**Subject:** RE: Notice of Complete Application & Public Meeting (D30-021-2024 - 112 King St)

**RE:** Request for Comments

**File No.:** D30-021-2024

**Location** 112 KING ST

**MINIMUM VERTICAL CLEARANCES OF WIRES, CABLES AND CONDUCTORS ABOVE GROUND OR RAILS**

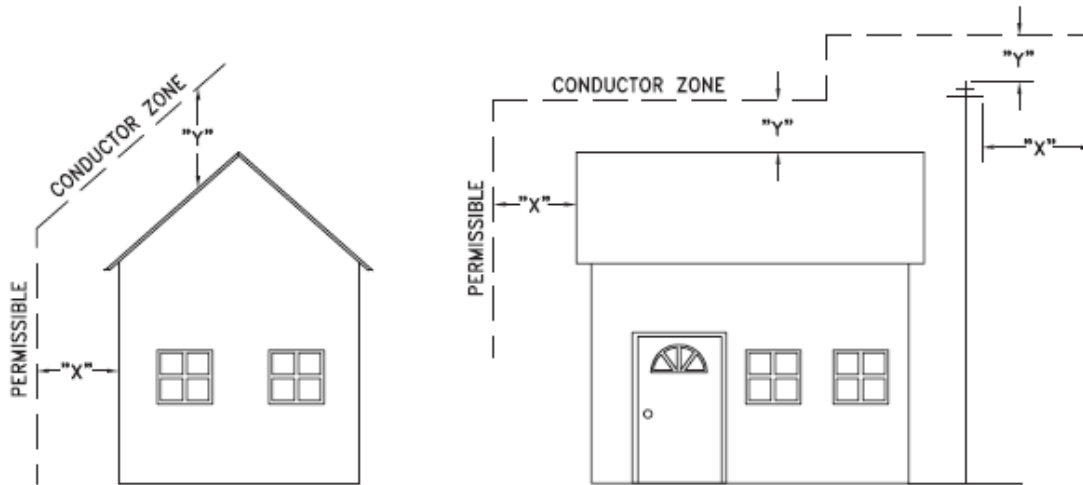
We have no objection to the zoning change with the understanding the new project must meet the clearances from our lines. In the event that the building commences construction, and the clearance between any component of the building structure and the adjacent existing overhead and underground electrical distribution system violates the Occupational Health and Safety Act, the customer will be responsible for 100% of the costs associated with Alectra making the work area safe. All construction work will be required to stop until the safe limits of approach can be established.

In the event the building is completed, and the clearance between the building and the adjacent existing overhead and underground electrical distribution system violates the any of applicable standards, acts or codes referenced, the customer will be responsible for 100% of Alectra's cost for any relocation work.
